# WOLF CREEK NUCLEAR OPERATING CORPORATION

March 3, 2013  
ET 13-0009

Subject: Docket No. 50-482: Clarification of Request for Additional Information Regarding License Amendment Request to Revise Technical Specification (TS) 3.8.1, "AC Sources - Operating"

## Response to Request for Clarification of Additional Information

Figure 1 – ESW Pump Motor 'A'

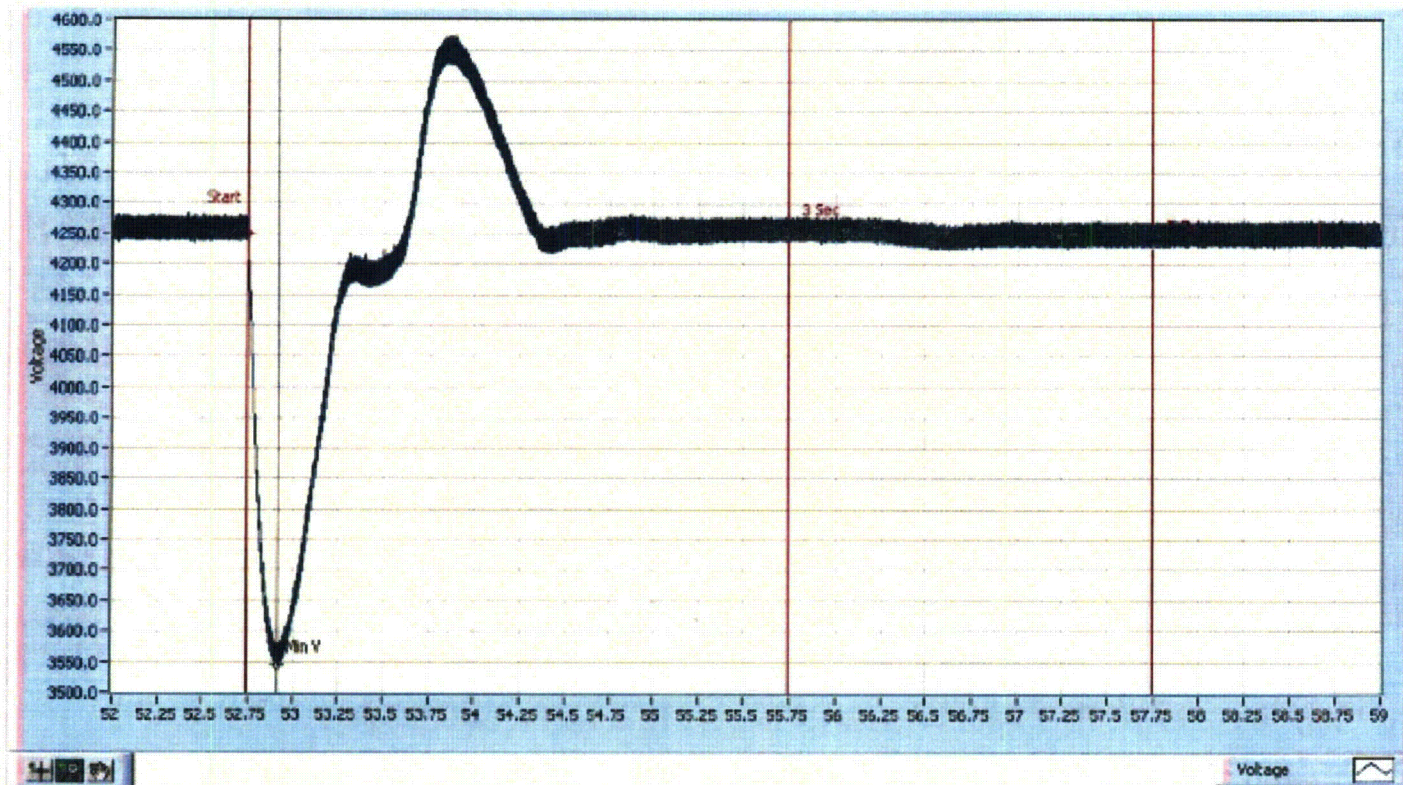
1. *The LAR is proposing a minimum voltage of 3950V. With the DG output at 3950 Volts, provide the following details when the ESW pump STARTS:*
  1. *The instantaneous voltage at the safety busses monitored by protective devices such as degraded voltage and loss of voltage relays and clarify if any relays may actuate.*

The DGs achieve approximately 4250V upon starting. A slightly elevated voltage is established to assure the DG voltage is maintained above 3120V when starting the large 1750 horsepower Essential Service Water (ESW) pump motors. This is consistent with the design considerations of Regulatory Guide 1.9, Revision 3, "Selection, Design, Qualification, and Testing of Emergency Diesel Generator Units Used as Class 1E Onsite Electric Power Systems at Nuclear Power Plants." Table 1 provides data from the performance of Surveillance Requirement (SR) 3.8.1.7, that the DGs consistently achieve a voltage around 4250V. SR 3.8.1.7 requires that the DG starts from standby conditions and achieves required voltage and frequency within 12 seconds, and subsequently achieves steady state required voltage and frequency ranges. Figure 1 provides the results of the start of the 'A' ESW pump motor during the 18 month integrated emergency safety features actuation surveillance testing. This figure is

representative of both ESW pump motors and shows adequate margin to the design considerations of Regulatory Guide 1.9.

Limit	Actual
Minimum voltage:	3120 V	3545
Minimum voltage within 3 seconds after start:	3774 V	4262
Maximum voltage within 5 seconds after start:	4320 V	4232
